# Service Bulletin

**SUBJECT:** Service Update for Inventory and Customer Vehicles  
Power Steering Hose Leak  
Expires with Base Warranty

**MODELS:** 2015 Chevrolet Silverado 2500/3500 HD  
2015 GMC Sierra 2500/3500 HD  
Serviced Before September 9, 2014 (Pursuant to Recall Bulletin 14356)

Subject: 14608 – Service Update for Inventory and Customer Vehicles -  
Power Steering Hose Leak

3975435

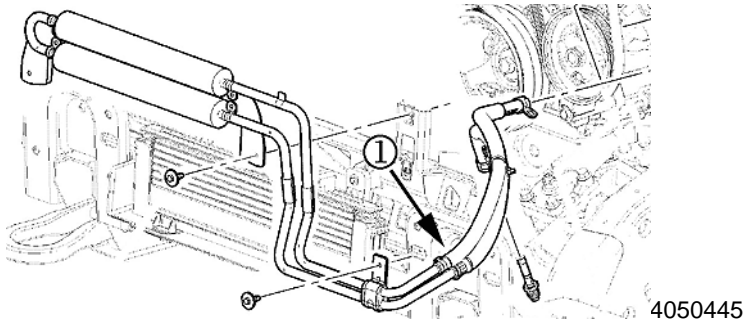
(A) Crimped ferrule with swedge marks. This is a secure connection on the pipe ferrule. (B) Uncrimped ferrule without swedge marks. This is NOT a secure connection on the pipe ferrule.

1. Open the hood and locate the section of the power steering cooler lines where the rubber hoses join the metal pipes (1).
2. Verify there is a metal collar (ferrule) on the both rubber hoses where they join the metal pipes.

3. Verify that both ferrules are crimped and display the swedge mark. Pull on the crimped end of the hose to determine if hose crimp is loose (not secure) on the pipe ferrule.

- If the power steering hose is missing a ferrule, the crimps are NOT secure or DO NOT show evidence of swedge marks, **replace the power steering fluid cooler**. Refer to *Power Steering Fluid Cooler Replacement (Heavy Duty)* in SI.
